May 26, 2017

TO : All Bidders
FROM : George M. Wiens
PROJECT : CTE Classroom Addition
1615400.41
SUBJECT : Addendum 1
DSA : 04-115755 / 33-H18

DETAILS
 DRAWING NUMBER: **M4-2**

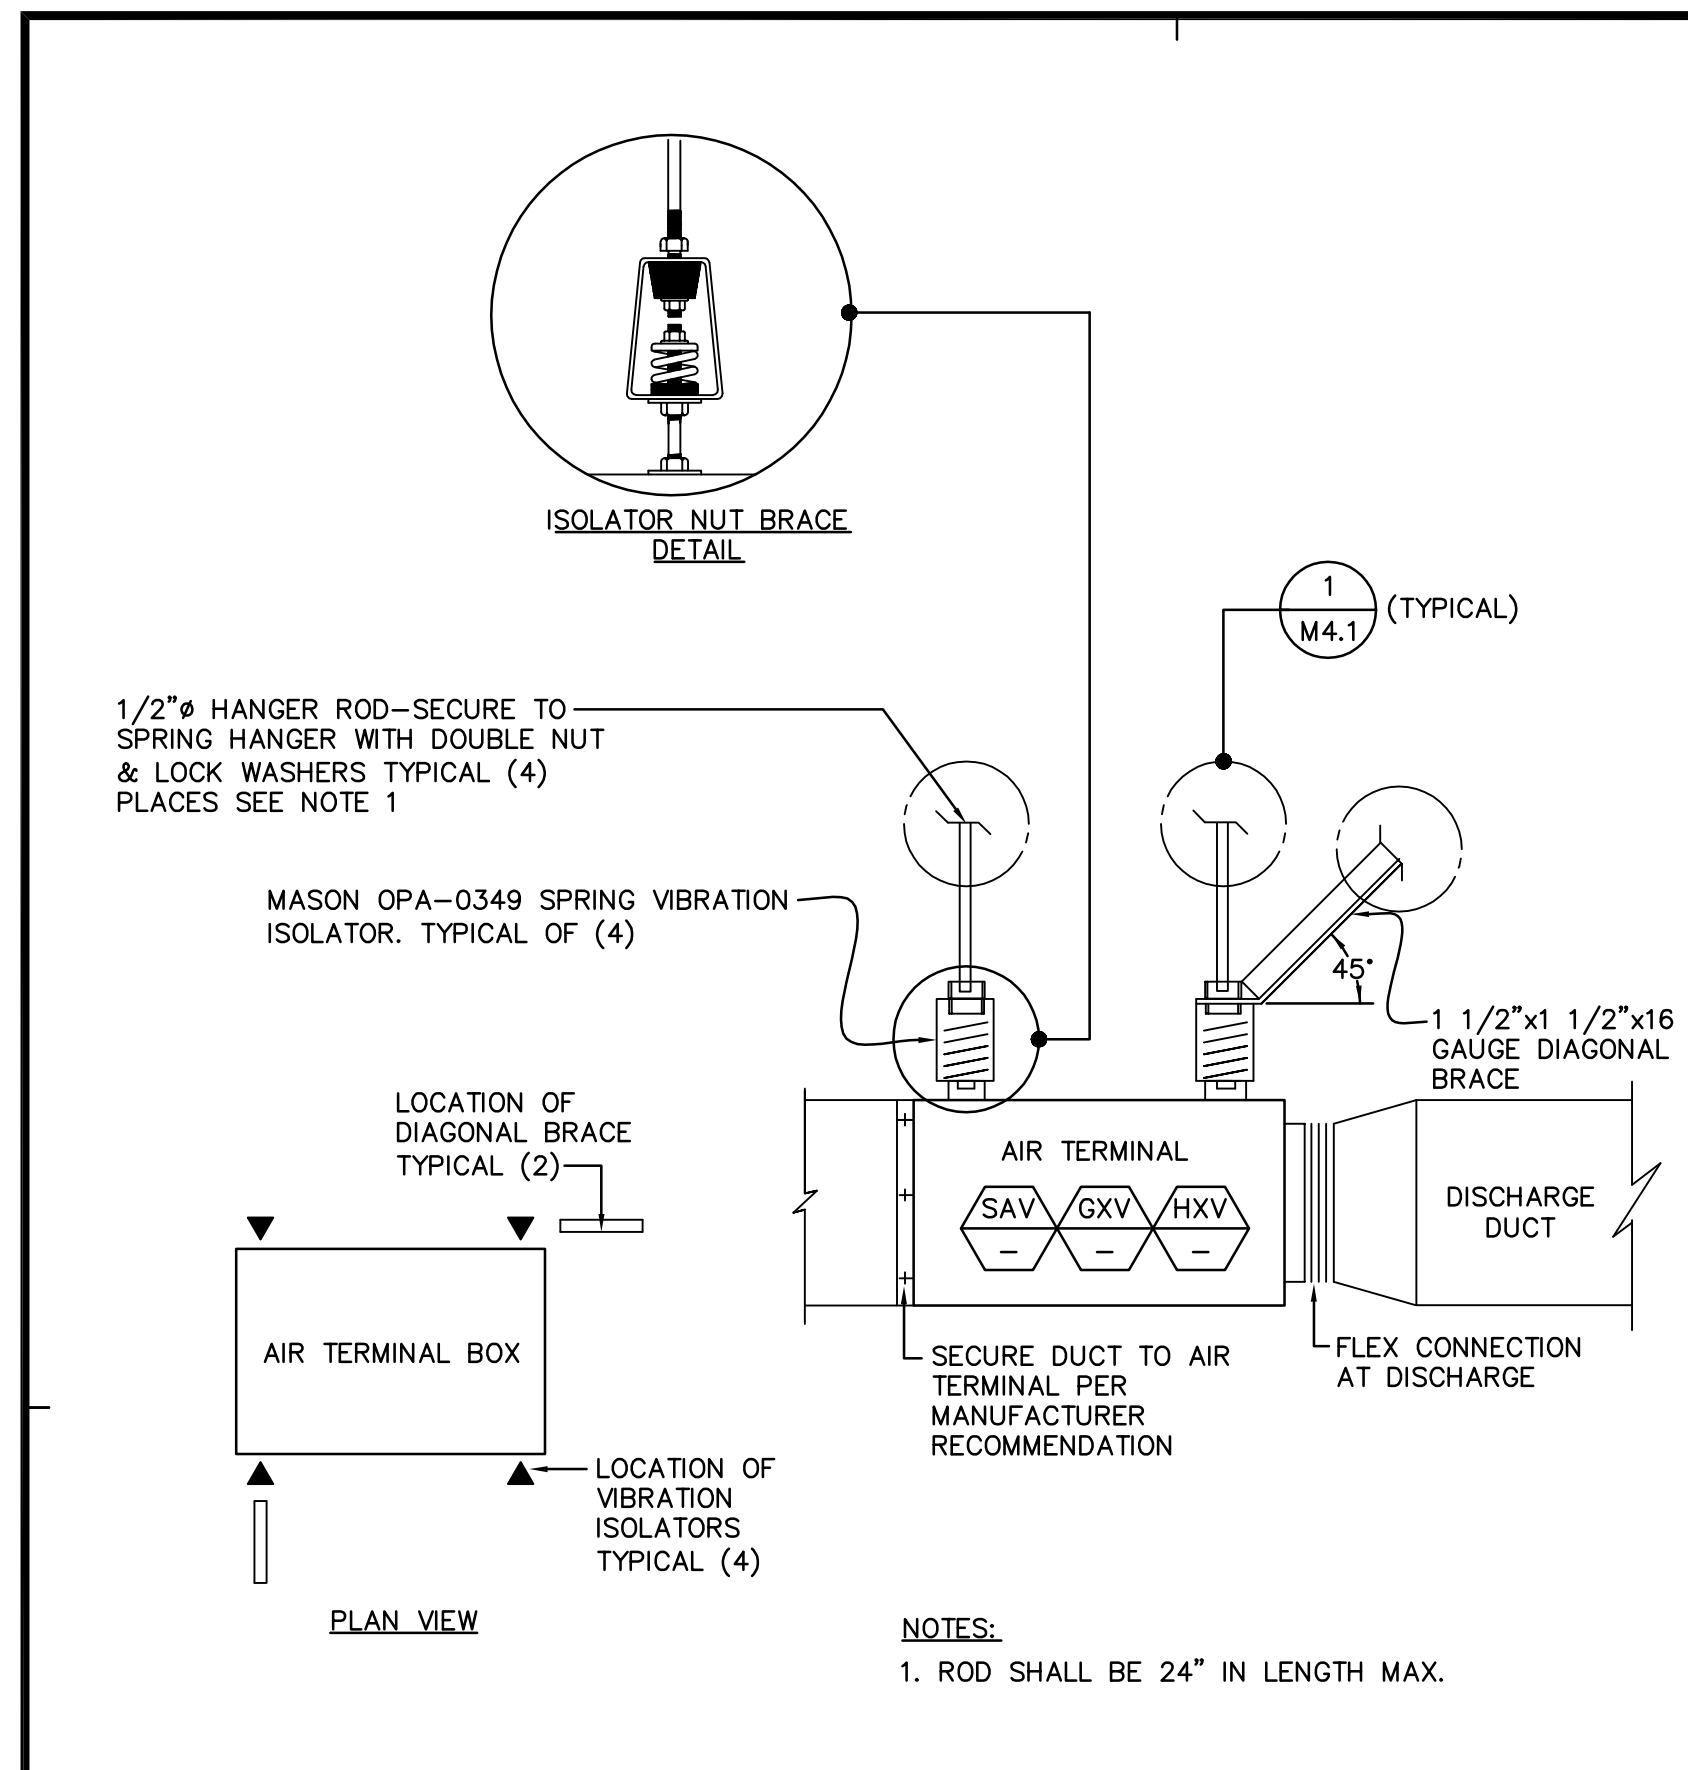
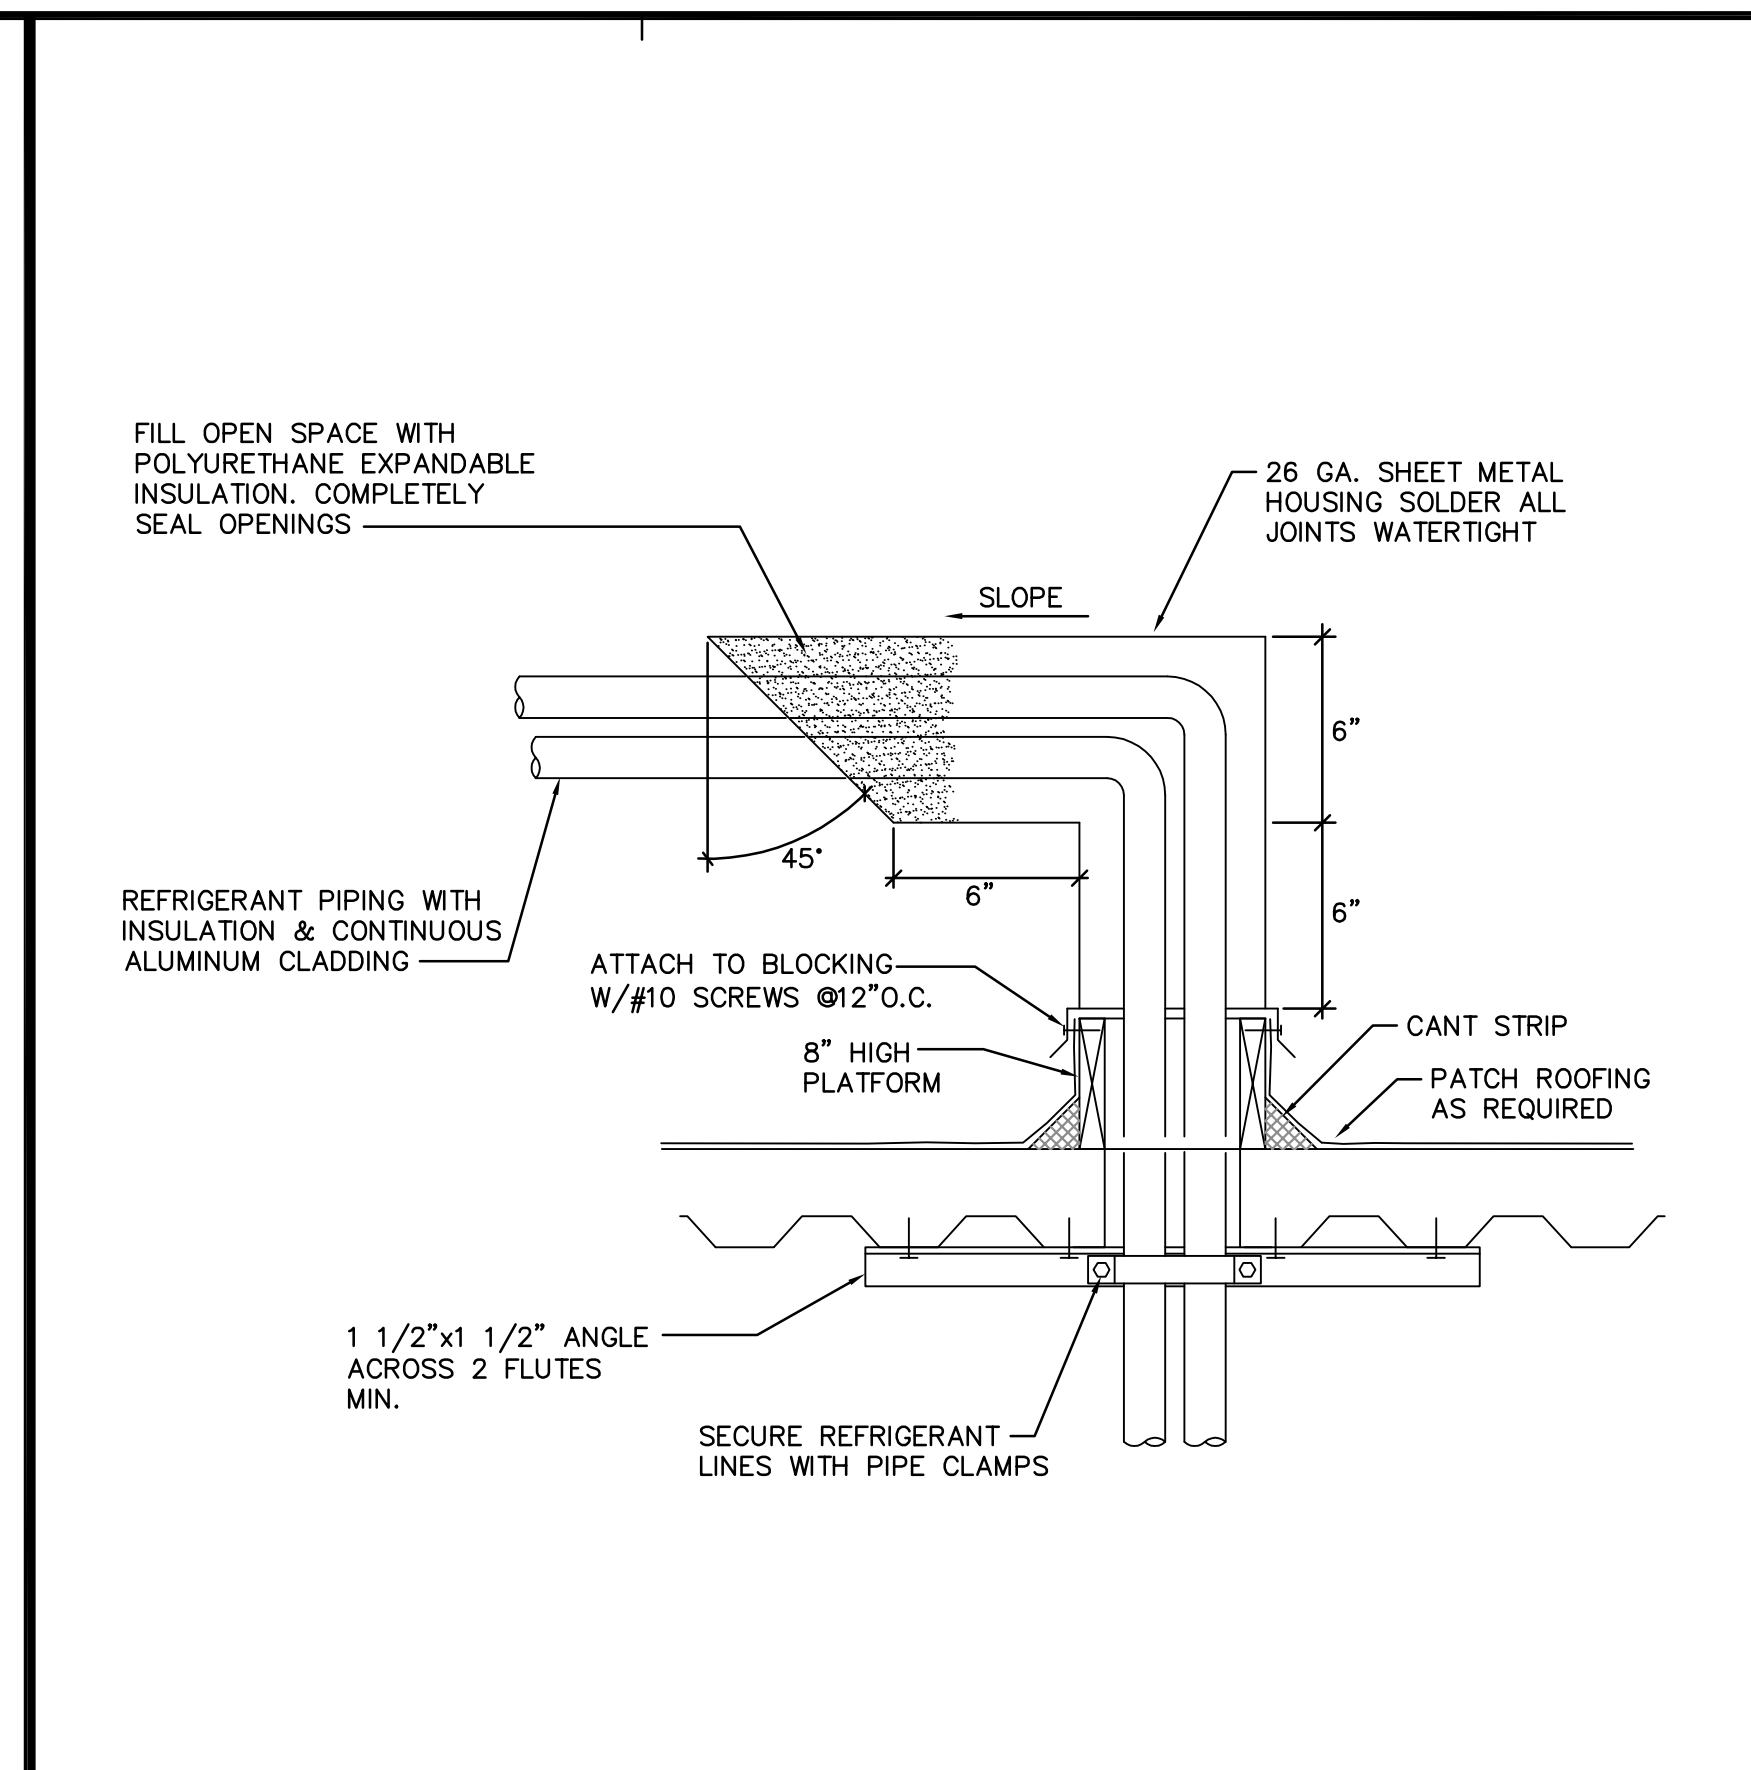
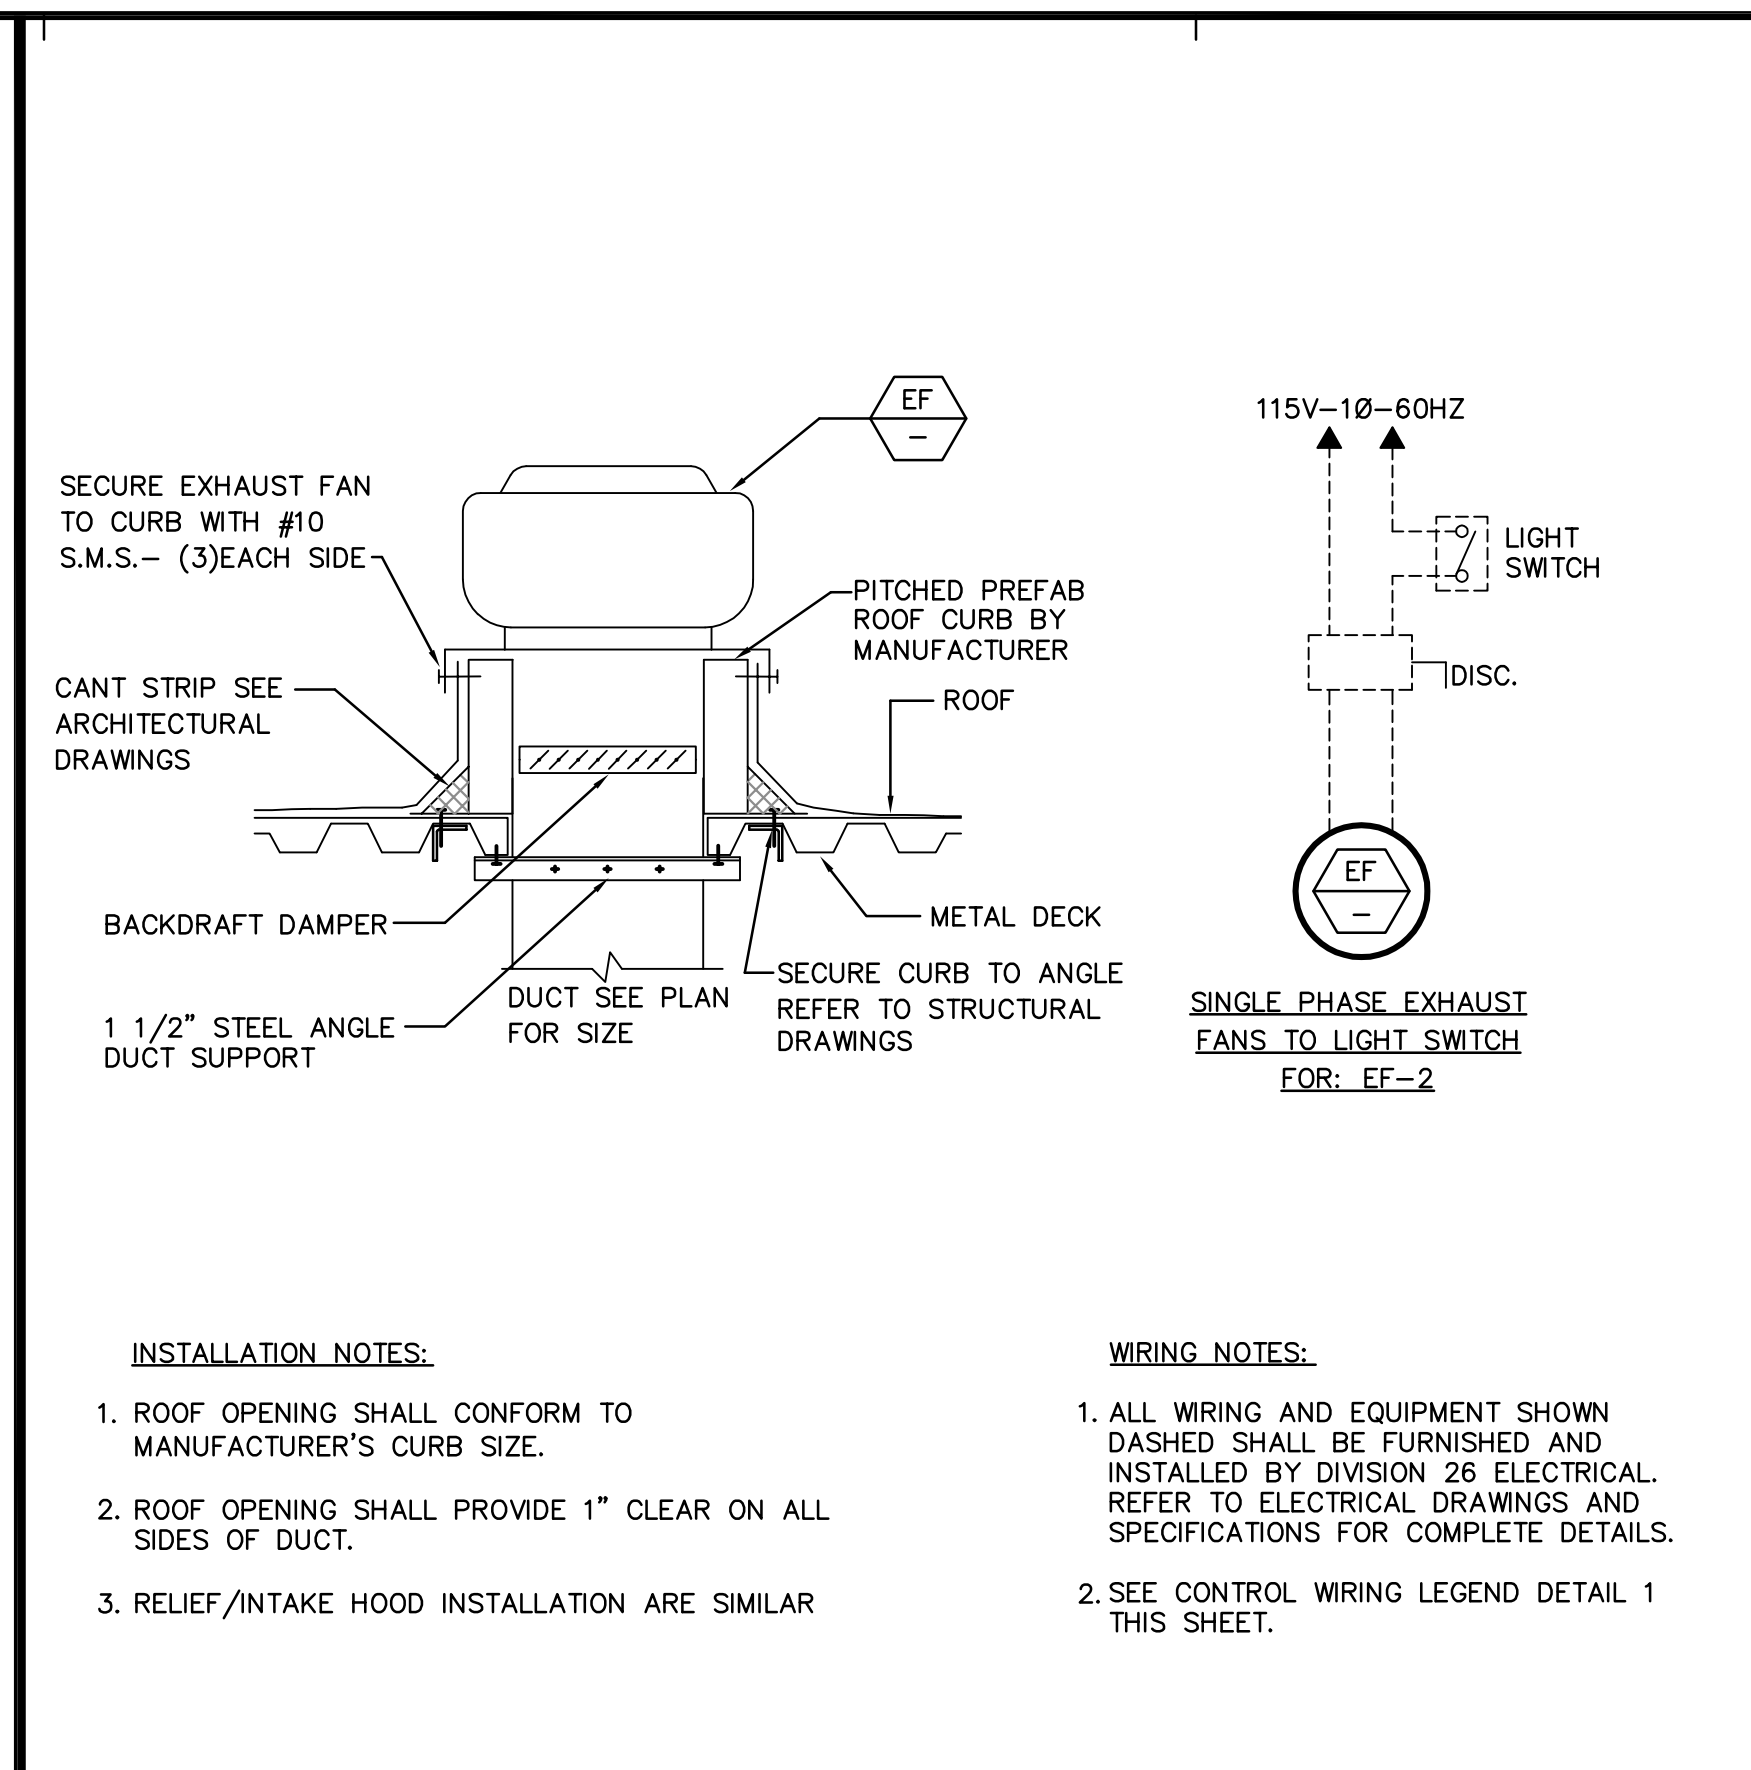
- A. Revise as indicated in the clouded area labeled Delta 1 on the attached M4.2.
